SERVICE BULLETIN # 1013

SUBJECT Installation of McCulloch Sprocket, Drum and Bearing Assemblies.

MODEL Competitive Saws DATE 2-18-58

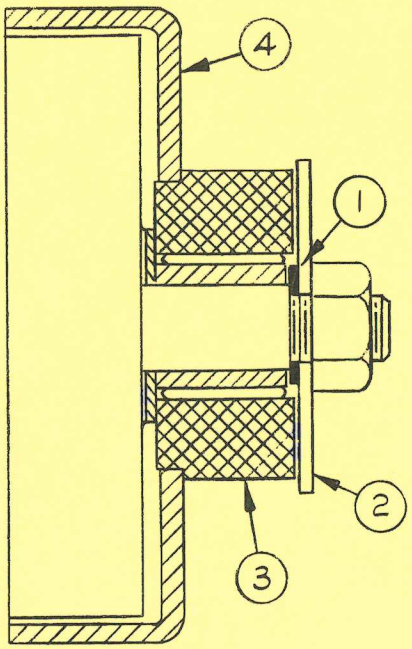
Since the McCulloch sprocket is slightly wider than the Homelite sprocket, the special spacer(1), part number 52591, is used to provide clearance between the Homelite outer thrust washer (2) and the McCulloch sprocket (3). The accompanying sketch illustrates the installation of the McCulloch Sprocket, Drum and Bearing Assembly (4) and the use of the special spacer.

NOTE: If a McCulloch Sprocket and Drum Assembly, without a bearing, is to be used, the needle bearing can be removed from the Homelite assembly and installed in the McCulloch Sprocket.
